# N5106A-01 SERVICE NOTE

# N5106A (PXB) MIMO Receiver Tester

External Trigger in signal requires an input greater than 1.6V to trigger the unit.

Schematic: REAR PANEL

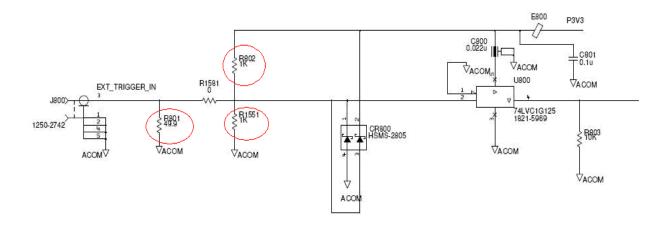
The N5106A External Trigger input is 50 ohms. When an external trigger source is used that has a 50 ohm output impedance the External trigger signal needs to be at least 3.3V

Remove R801, R802, and R1551 (RED circled components)
R1581 is a zero Ohm resistor. This needs to be in place for the external trigger to work.

Remove resistors R801, R802, and R1551 from the A11 System Clock board (N5105-60006). This will change the External input impedance to 1 Meg-ohm.
